**BAGHDAD POLICE COLLEGE  
BAGHDAD, IRAQ**

**SIGIR PA-06-078.2**

SUBJECT: Report on Project Assessments of Reconstruction Work Performed Under Task Orders 06 and 29 at the Baghdad Police College, Baghdad, Iraq (Report Numbers SIGIR PA-06-078.2 and PA-06-079.2)

## Baghdad Police College, Baghdad, Iraq

Figure 14. As-built drawing for the dining hall with no attached kitchen

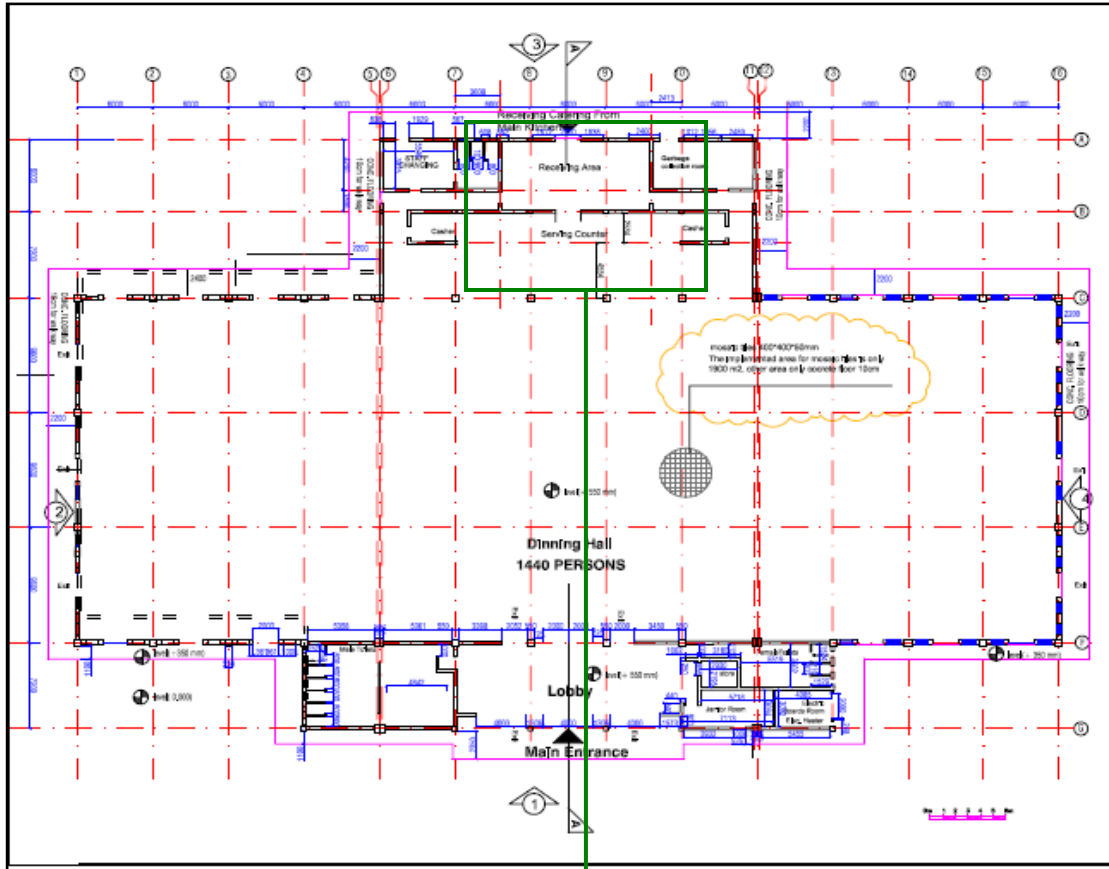
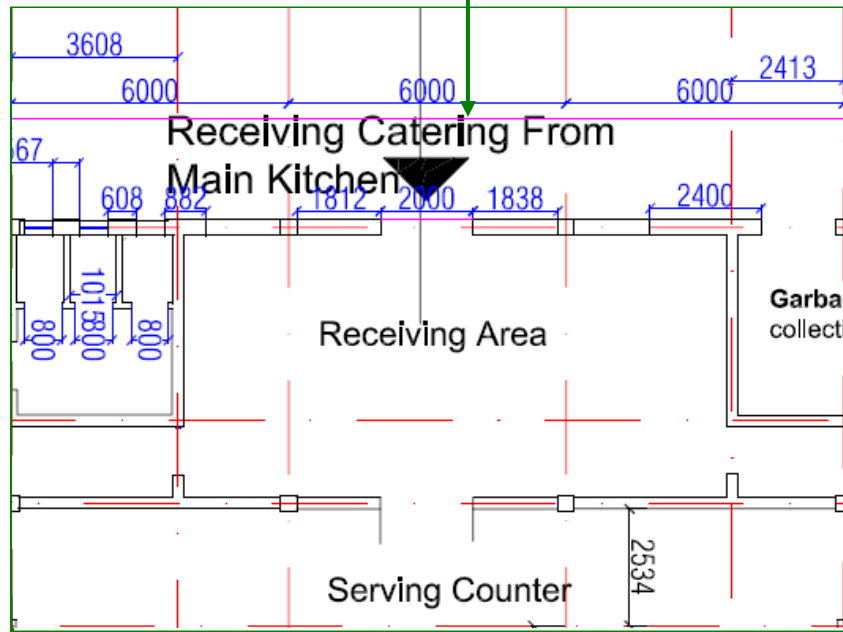
include the “attached” kitchen required by the TO. The government representative who reviewed Parsons’ design submittals did not mention the complete omission of the attached kitchen. GRD representatives, including the QAR did not realize the omission, either. GRD representatives believed the small room attached to the dining facility was the kitchen; however, this room is actually the receiving and servicing area for the dining facility (Site Photo 194 and Figures 14 and 15). No comment or clarification regarding this issue was raised at the time of design review. When the dining facility is completed, food will have to be brought in from the existing kitchen located on the BPC grounds. GRD representatives are now attempting to locate funding to construct a kitchen for the dining facility.
